**ADDENDUM
NO. 2**

November 3, 2022

**LIBERTY ELEMENTARY SCHOOL RENOVATIONS
Chesterton, IN 46304**

This Addendum consists of Pages ADD 2-1 through ADD 2-3 and attached Addendum No. 2 from Gibraltar Design dated November 2, 2022 and consisting of 7 pages, Specification Section 08 33 00 - Rolling Doors and Grilles, and 41 Drawings.

GIBRALTAR DESIGN SHEET
A-420

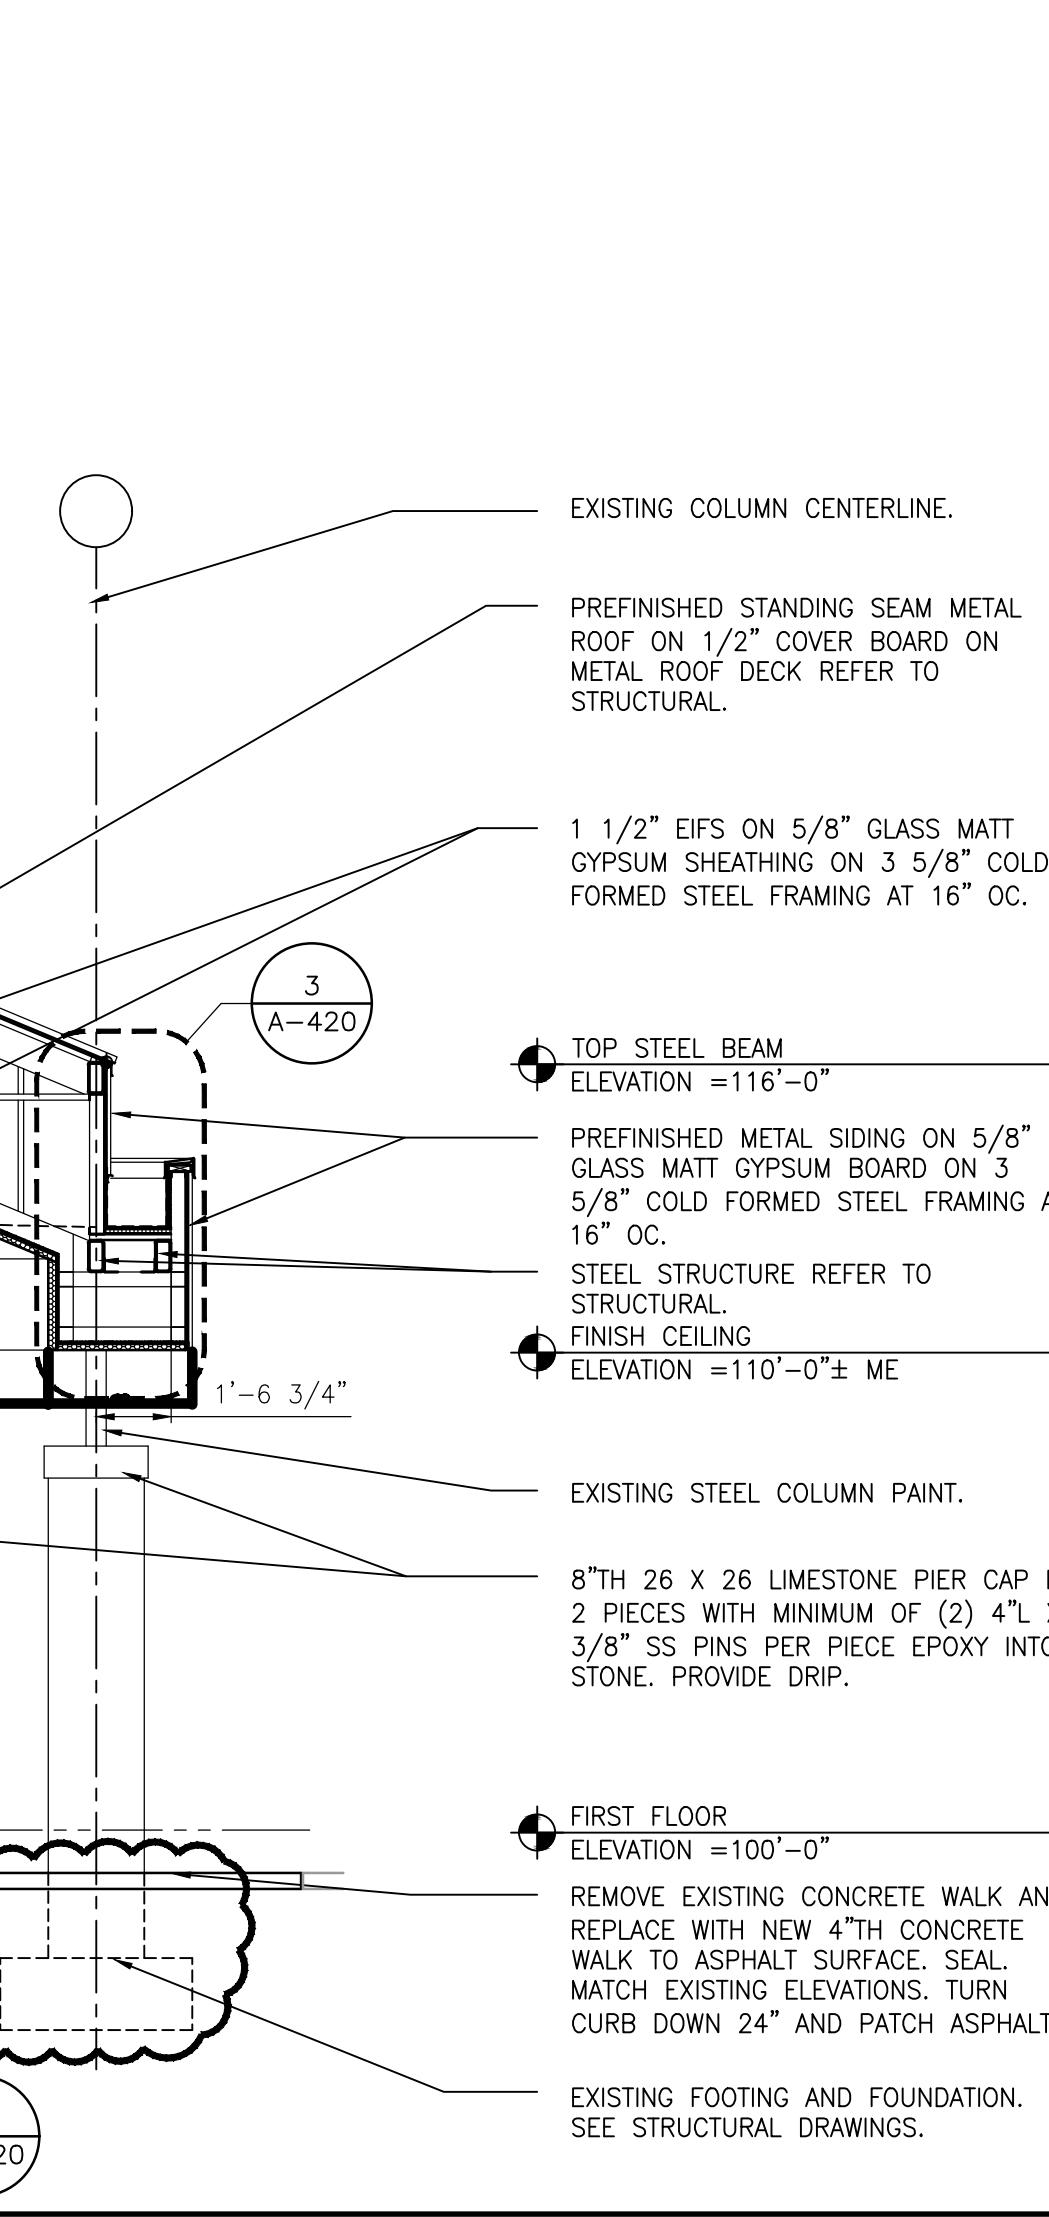
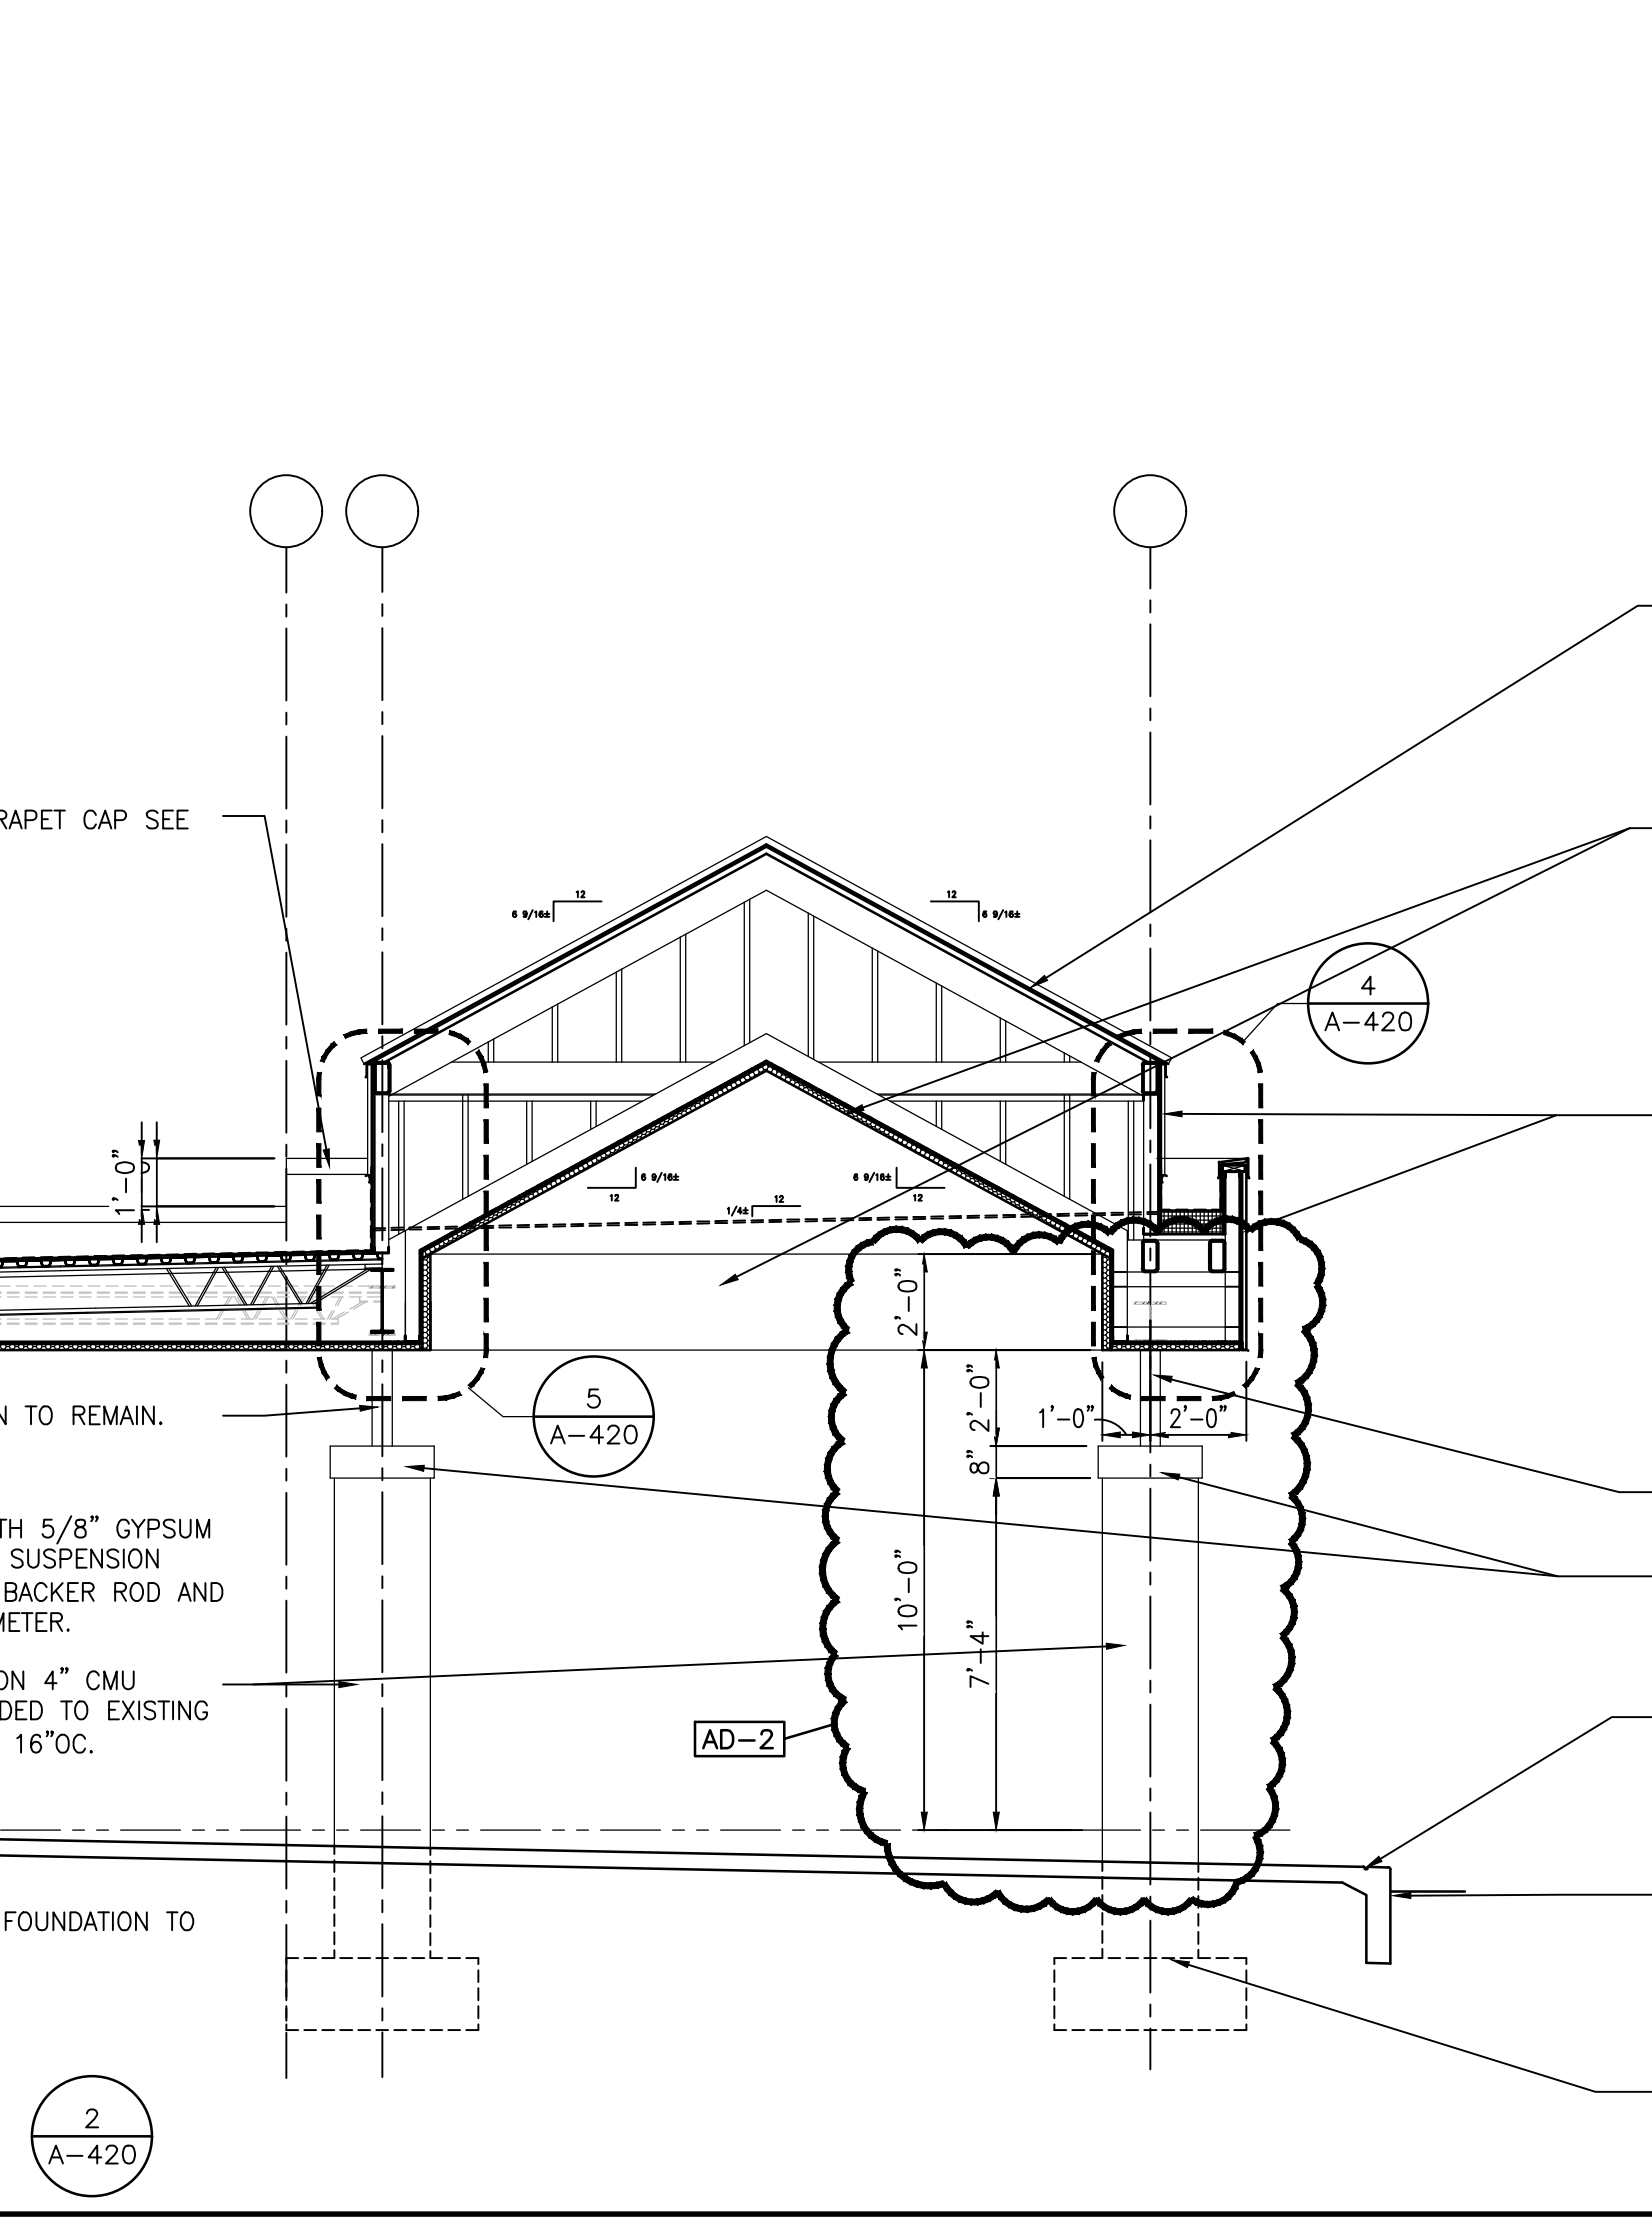
16. Sheet A-420

- A. Refer to revised full size drawings, included in this Addendum, for the following revisions:
1. Add dimensions for height of brick columns and offsets from existing column centerline.
 2. Clarify foundations shown in Wall Section 1/A-420.
